PSE&G Public Service
Electric and Gas
Company

August 10, 1984

HOPE CREEK GENERATING STATION
DOCKET NO. 50-354
DRAFT SAFETY EVALUATION REPORT
OPEN ITEM STATUS

Attachment 1 is a current list which provides a status of the open items identified in Section 1.7 of the Draft Safety Evaluation Report (SER). Items identified as "complete" are those for which PSE&G has provided responses and no confirmation of status has been received from the staff. We will consider these items closed unless notified otherwise. In order to permit timely resolution of items identified as "complete" which may not be resolved to the staff's satisfaction, please provide a specific description of the issue which remains to be resolved.

FIGURE A-14-1

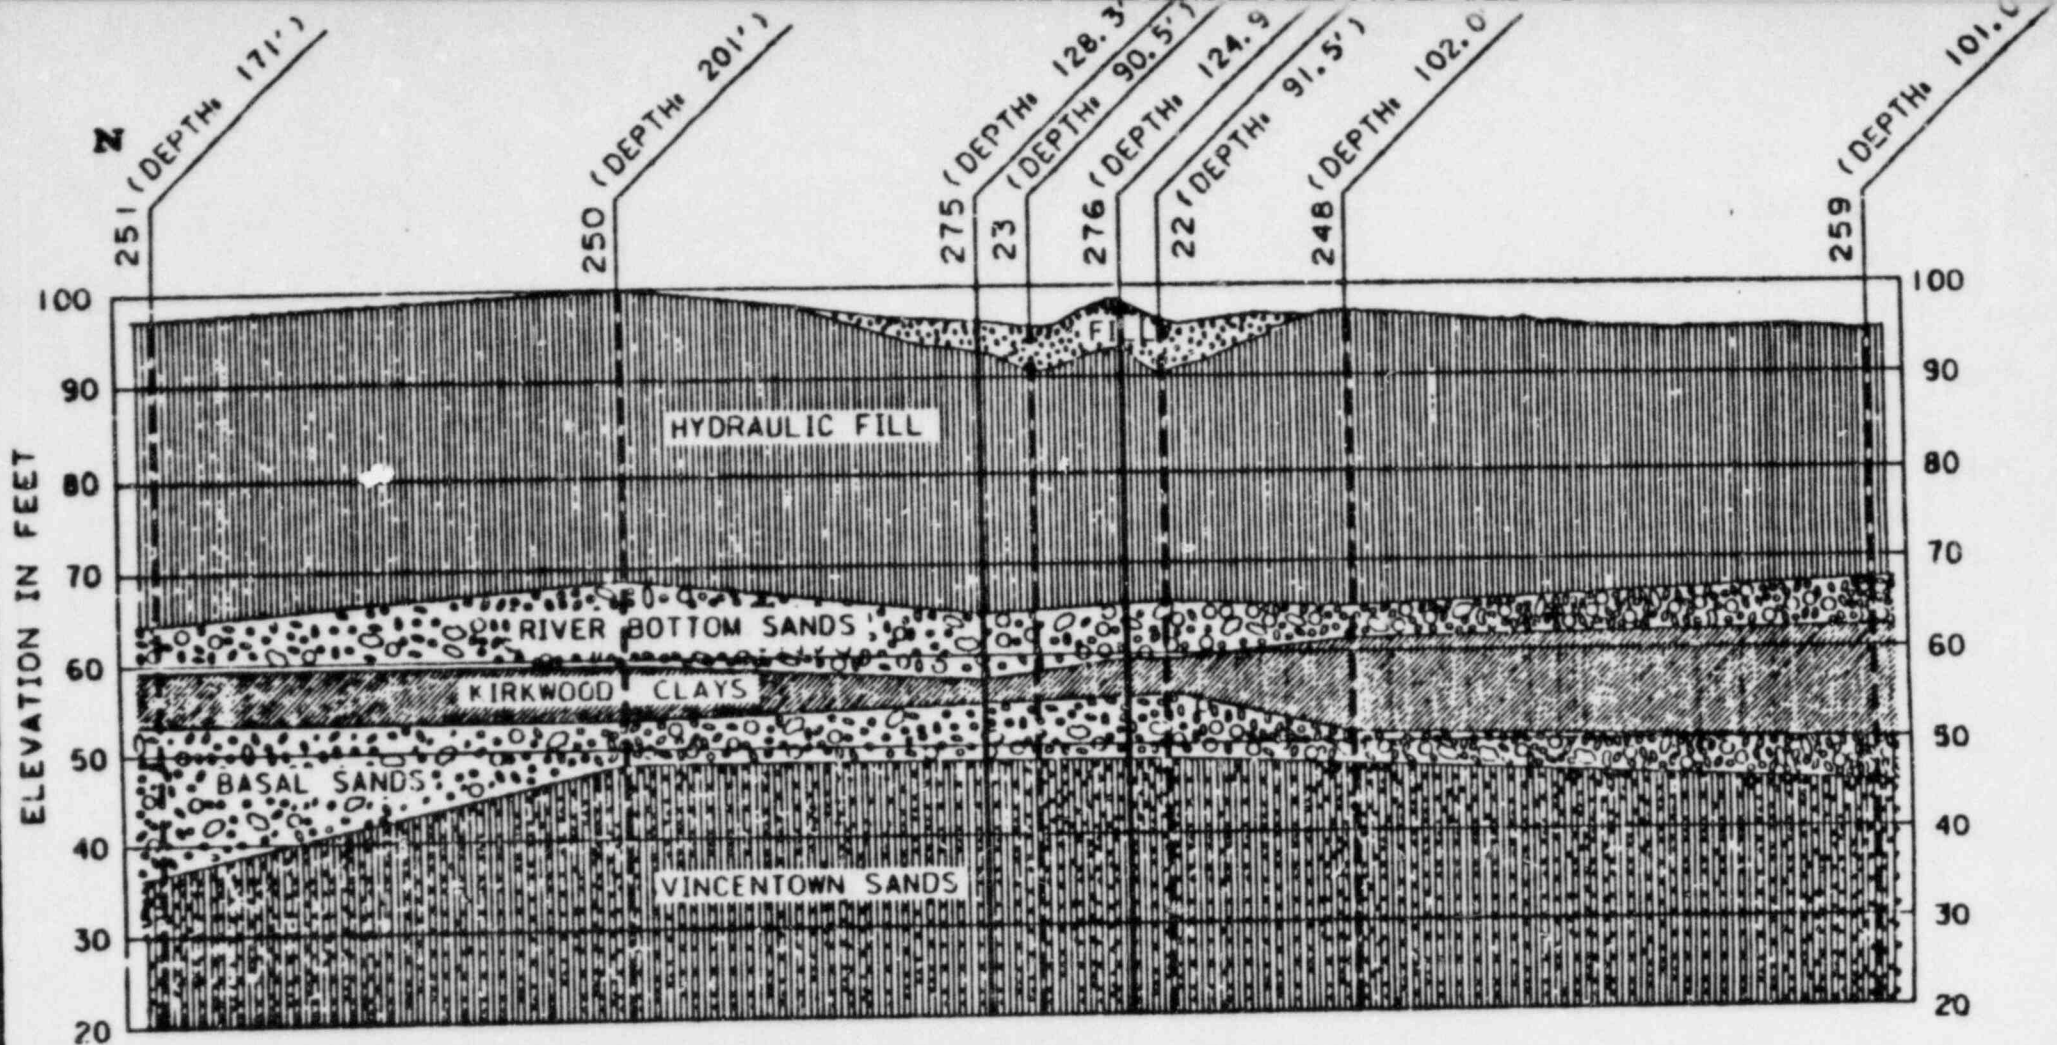
Question: Assess and justify that the current soil modeling for the intake structure adequately accounts for:

- o Soil property variability along the depth
- o Sheet piling
- o Layering of soil including inclined layering

As requested by the NRC, independent finite element analyses have been performed by Bechtel to verify the adequacy of the current design requirements for the Service Water Intake Structure (SWIS). Figure A-14-1 shows the plot plan of the SWIS and the adjacent sheet piles and cofferdams. The generalized North-South and East-West cross sections through SWIS are shown in Figures A-14-2 and A-14-3, respectively. To confirm the soil properties and soil profile offshore of the SWIS, four additional soil borings were performed in May 1984. This information was supplemented to the existing boring data to develop the soil profiles which were used as the basis for the soil structure interaction analyses described herein. Tables A-14-1 and A-14-2 show the simplified dynamic soil column models used for the seismic soil-structure interaction analysis (SSI) for the West (River) and East (Landward) side of SWIS area.

FIGURE A-13-2
 RESPONSE SPECTRA COMPARISON,
 UNIT 1 REACTOR BUILDING AT ELEV. 54' - 0".
 N-S, SSE, 2% DAMPING

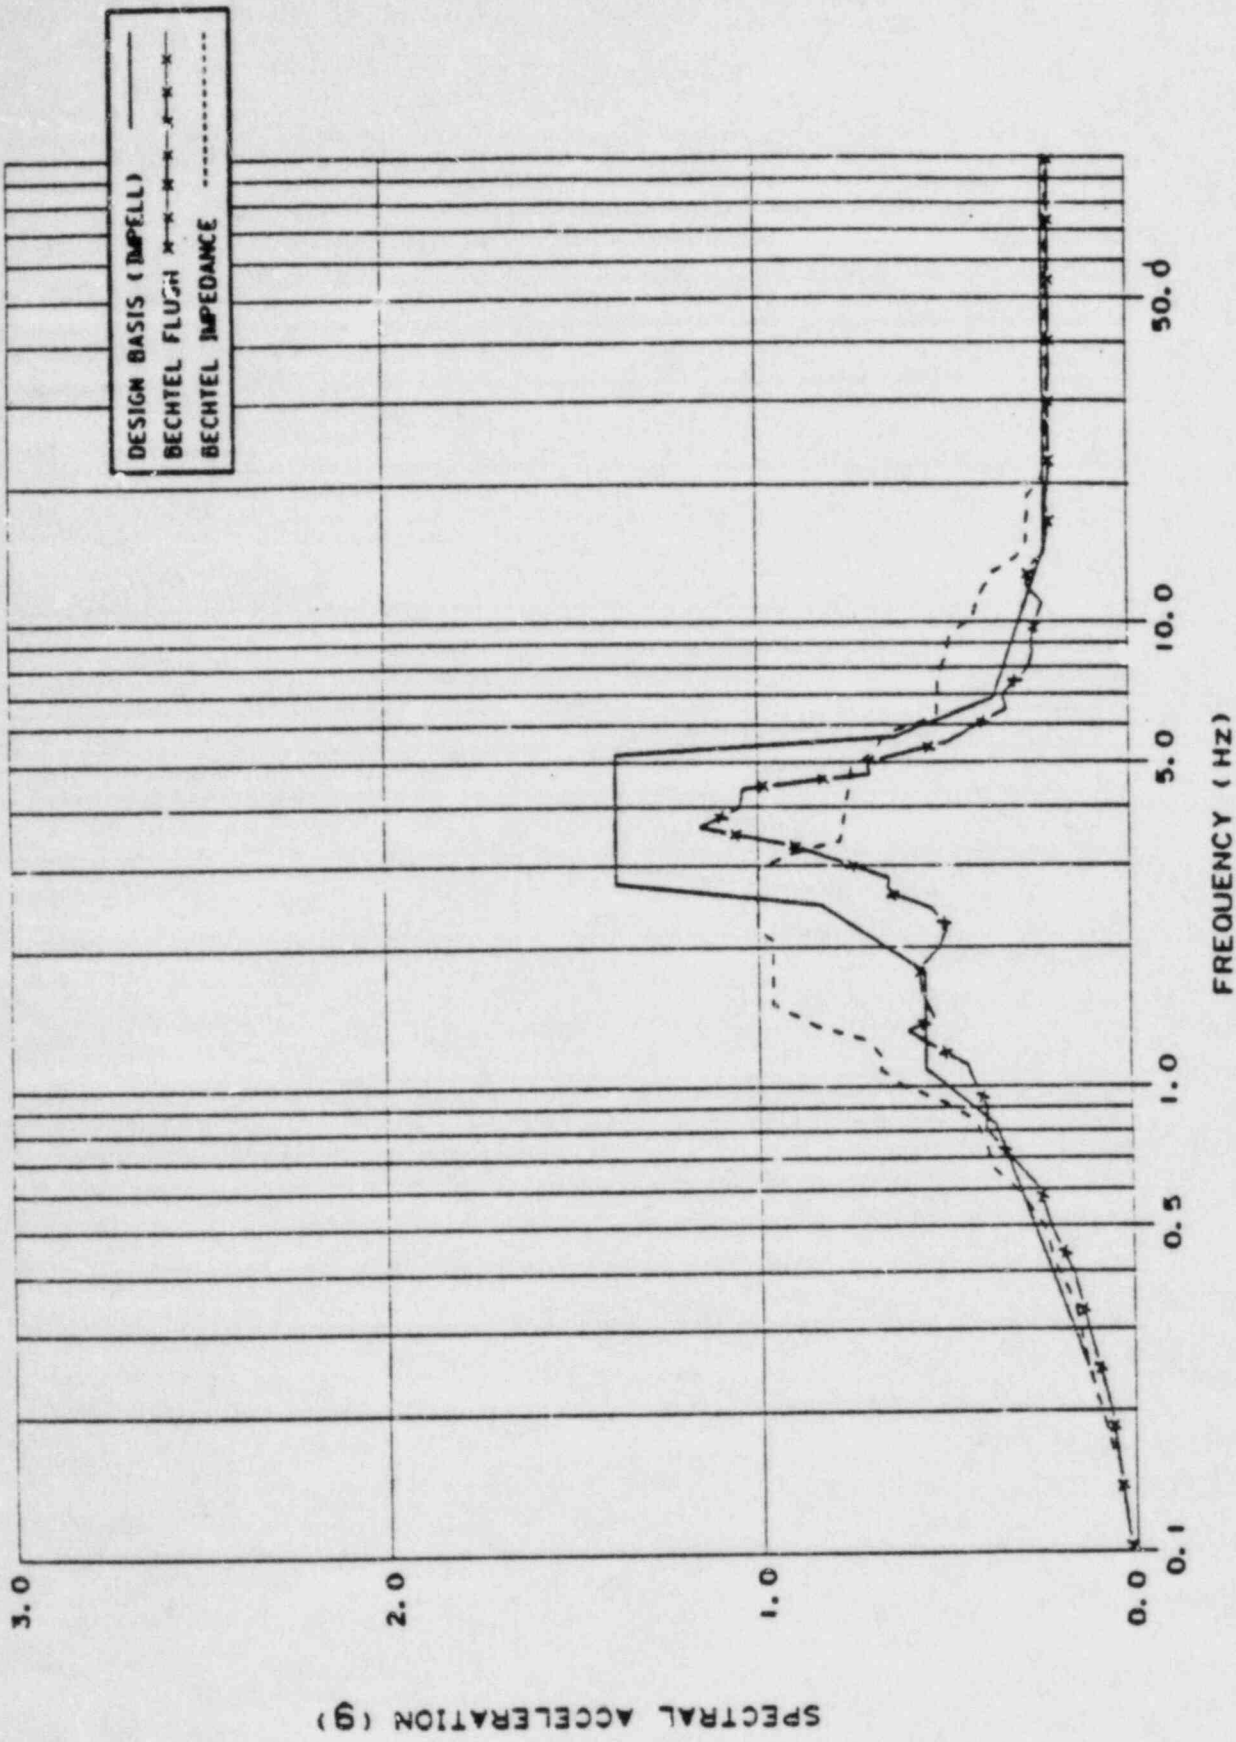
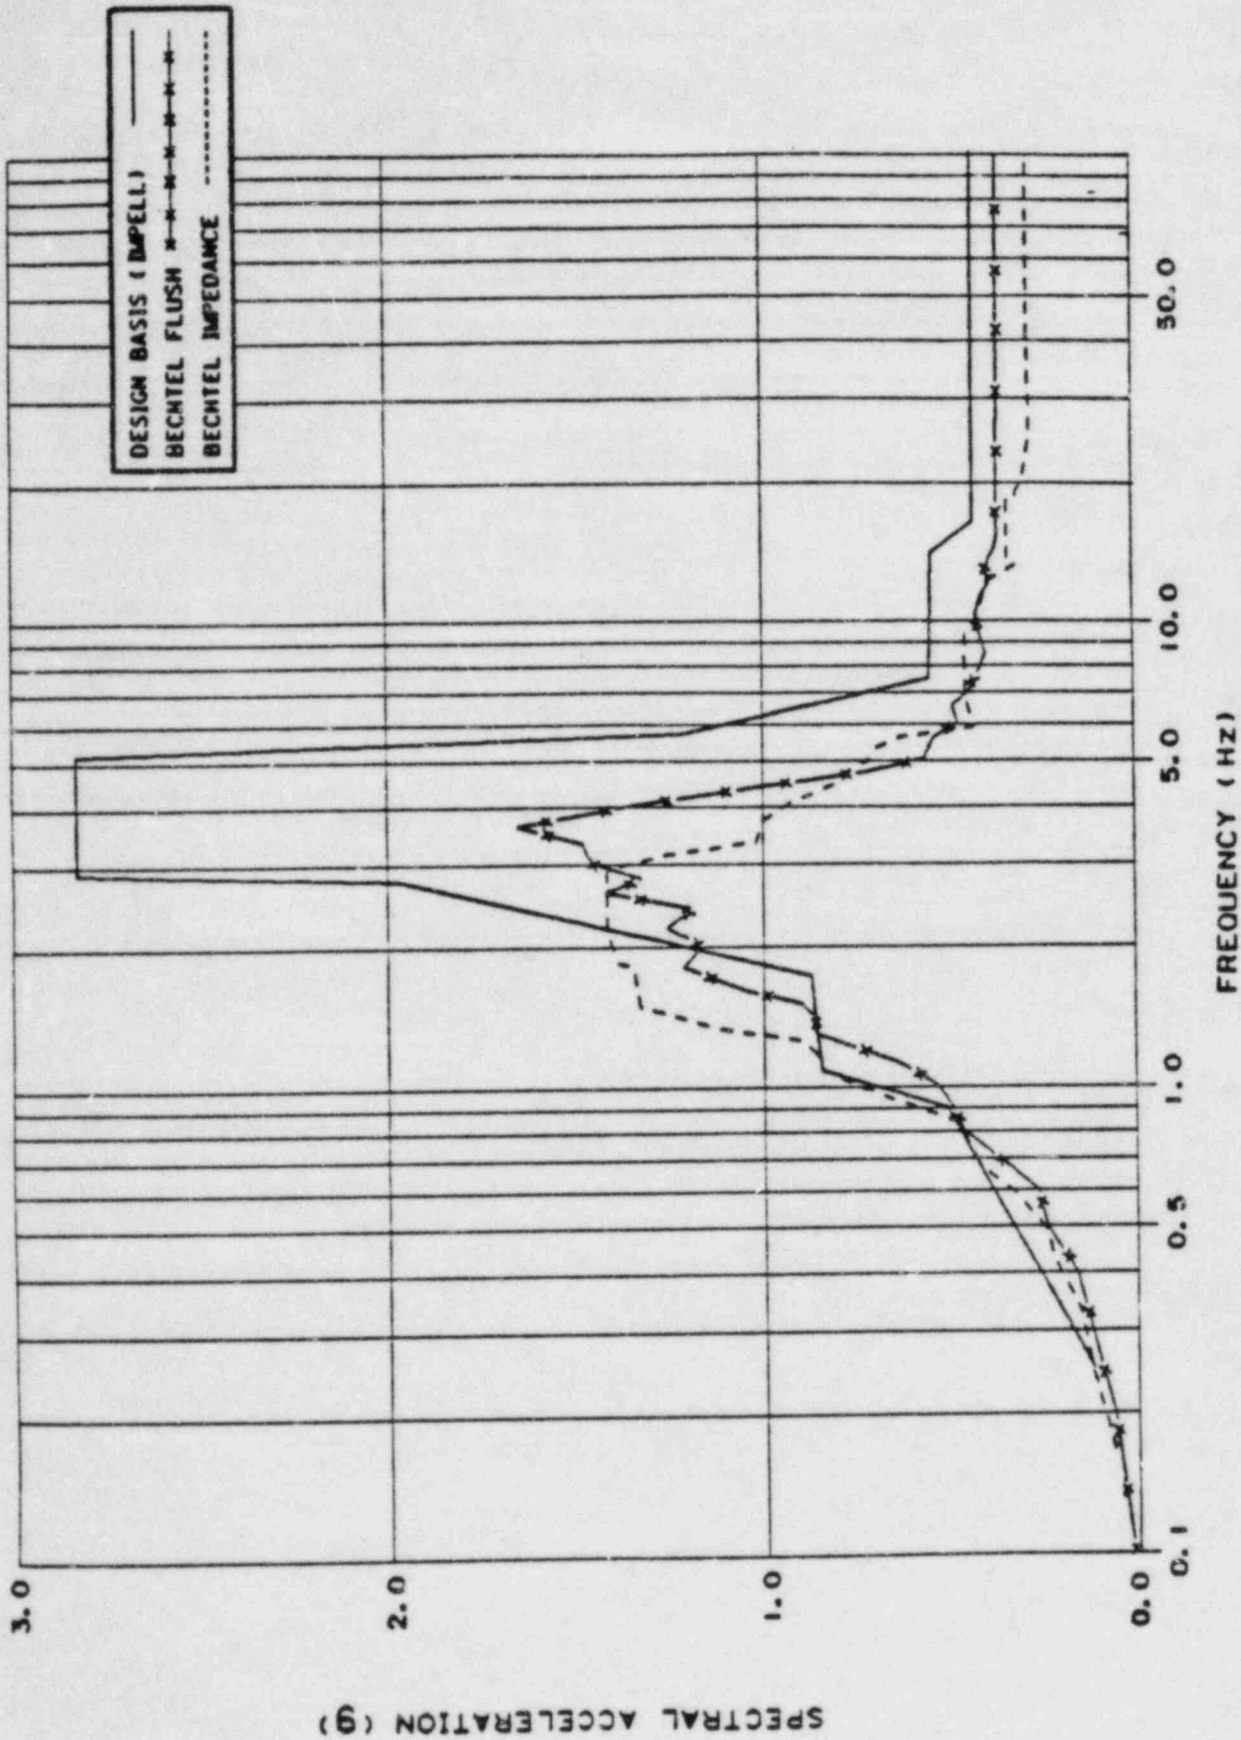
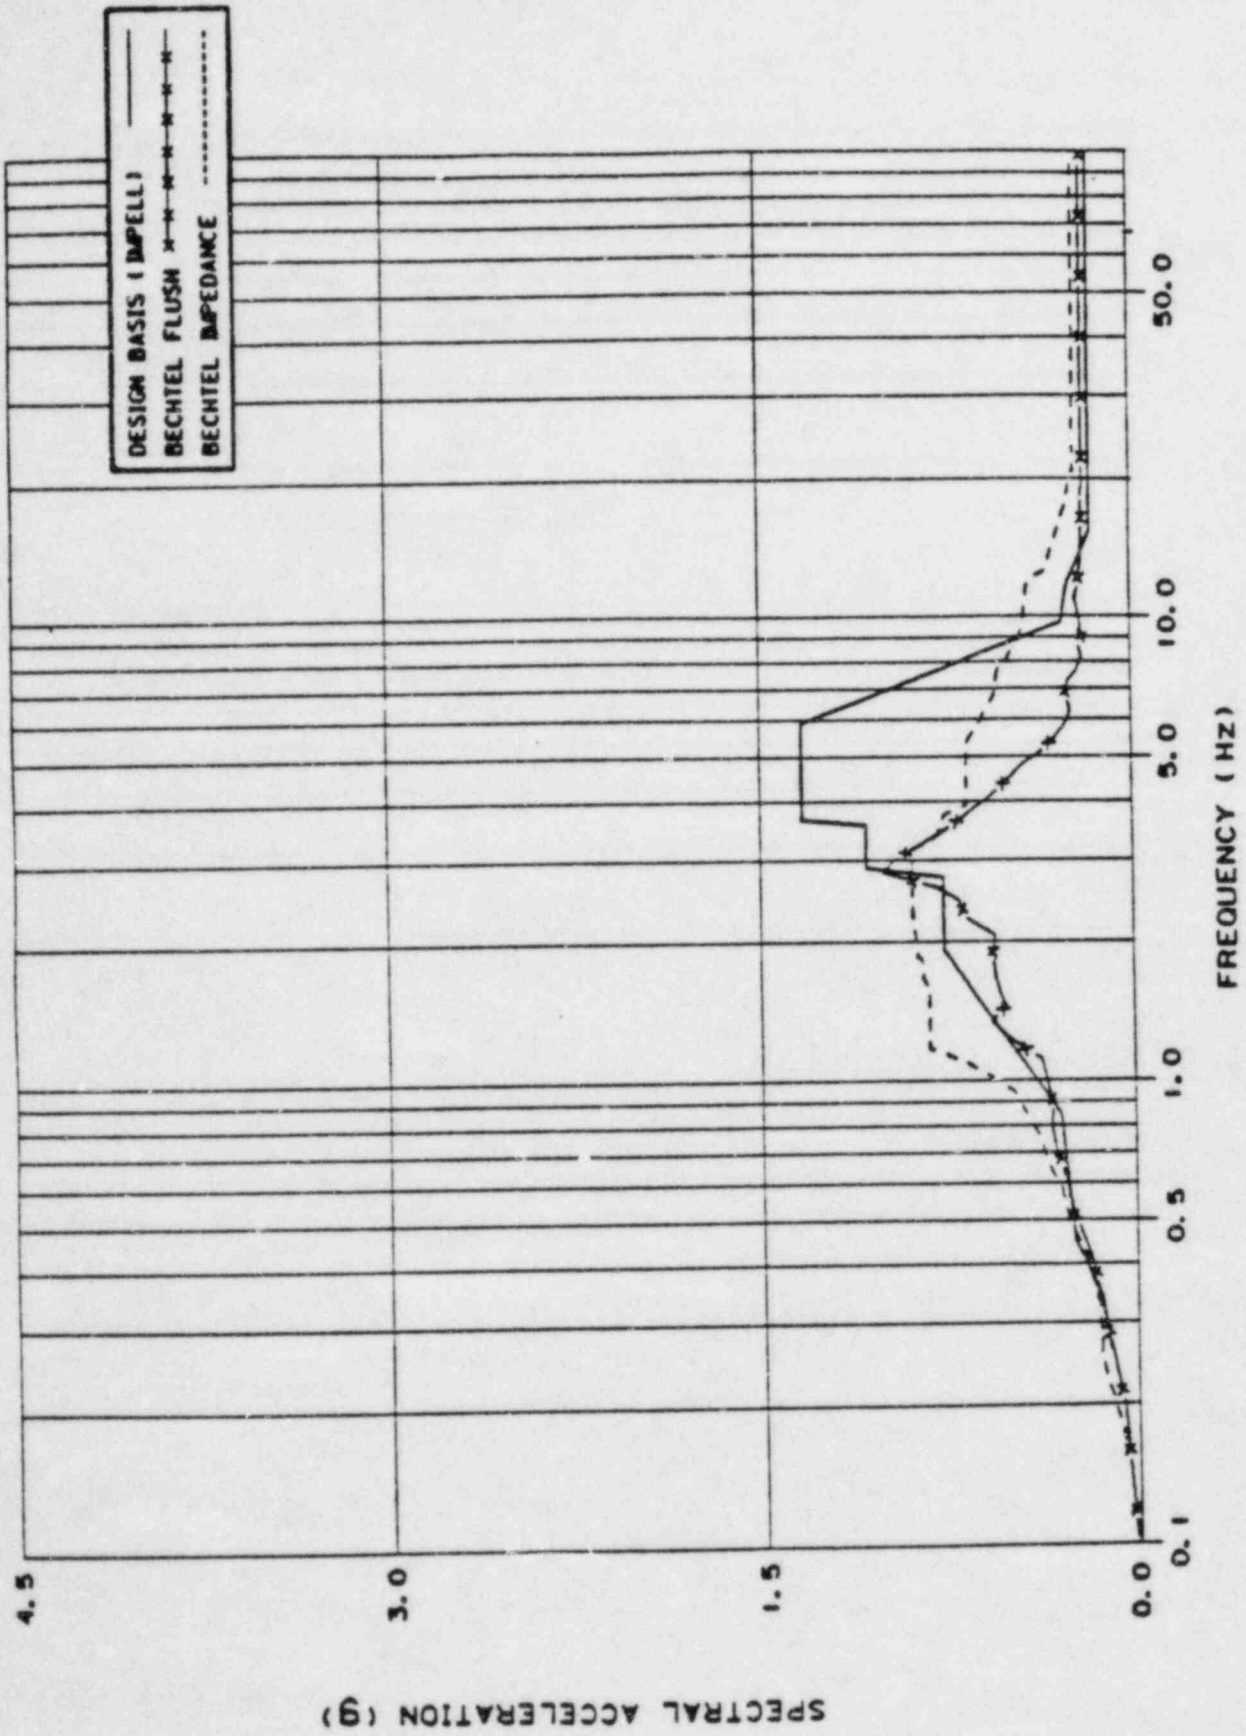
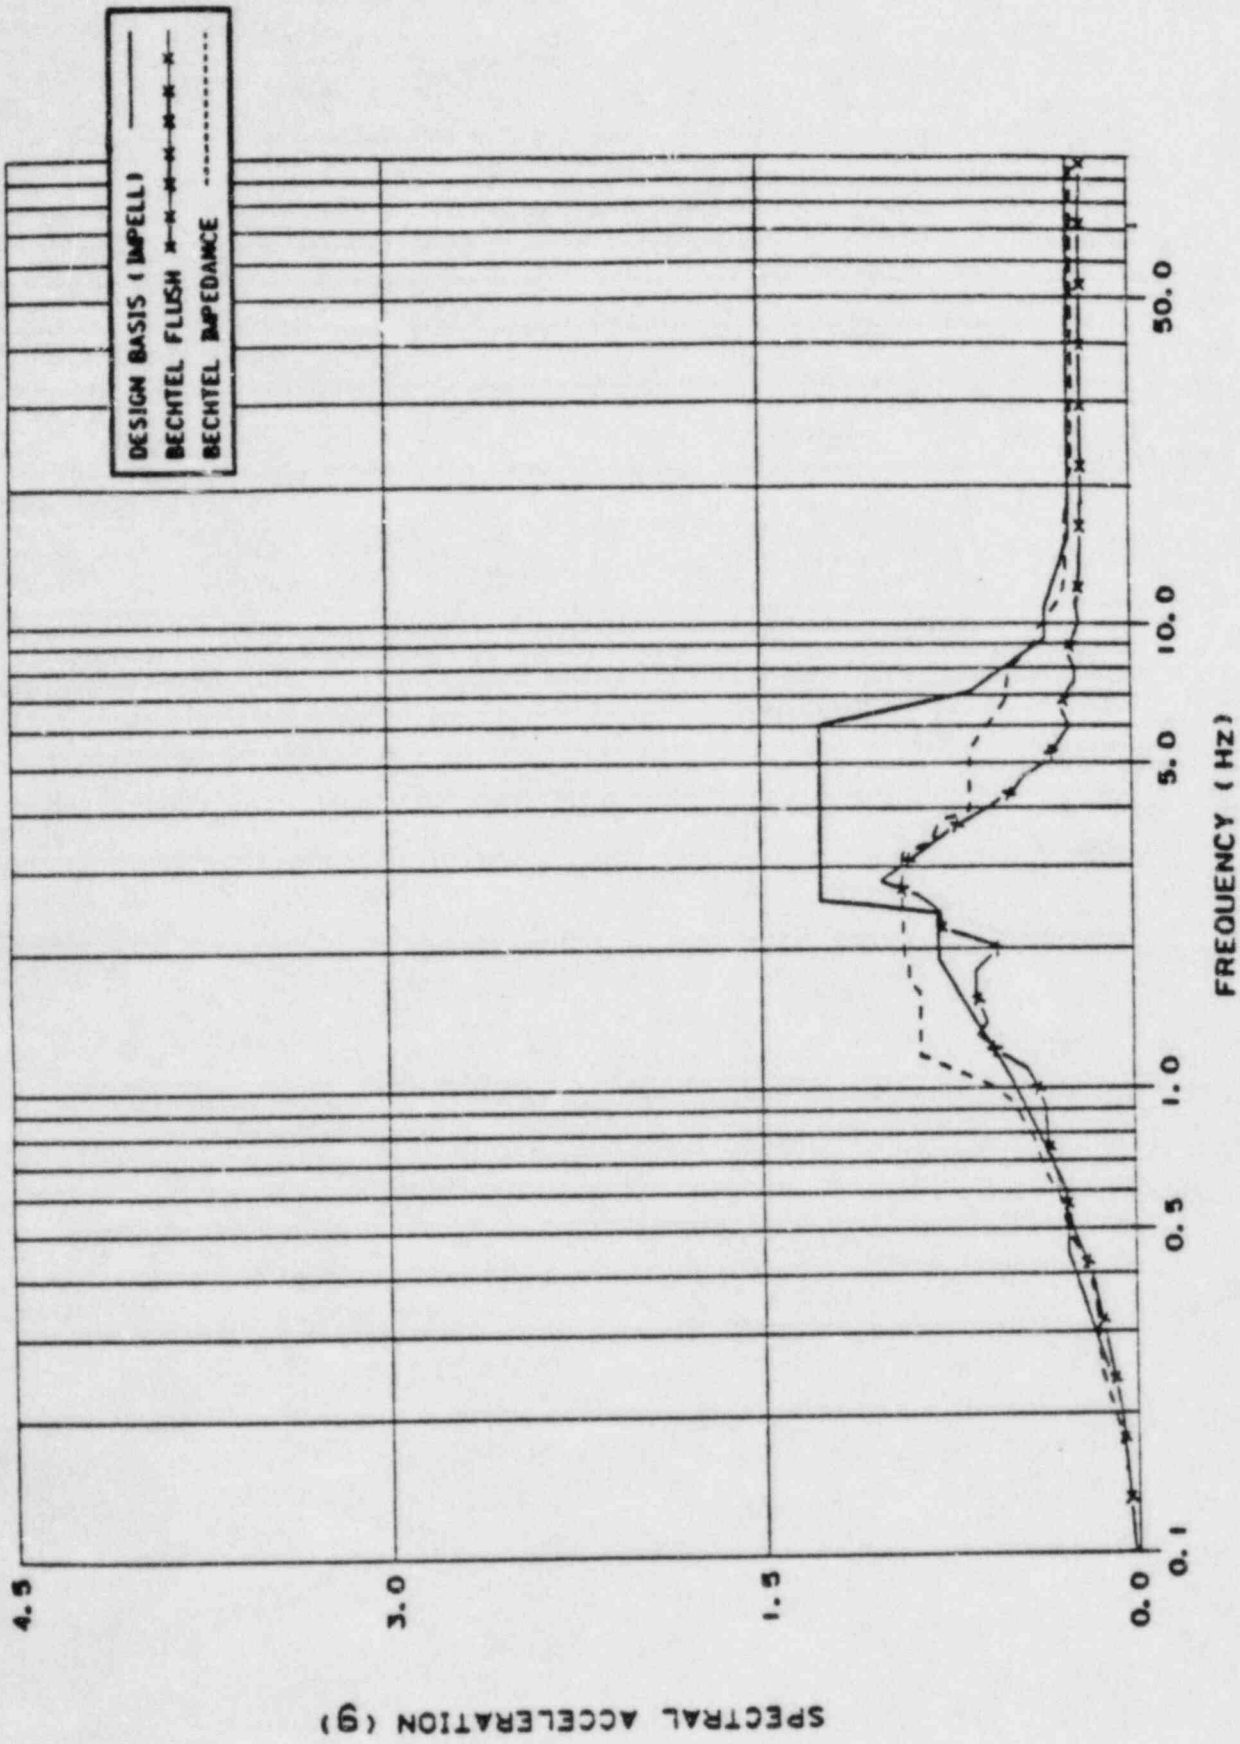
Question: Provide comparison of Bechtel Independent Verification Results with the Design Basis Results.

Figures A-13-2 to A-13-37 show the comparison of the response spectra (2% damping) obtained from the above three seismic soil-structure interaction analyses. Discussions of these comparisons are as follows:

The peak spectral accelerations obtained from the impedance approach analyses are generally lower than those obtained from the design basis analyses. However, these response spectra are not completely enveloped by those obtained from the design basis analysis, especially in the frequency range between 1.0 and 3.5 Hz. Also, there are some local exceedances in the higher frequency range, as shown in Figures A-13-2 through A-13-37.
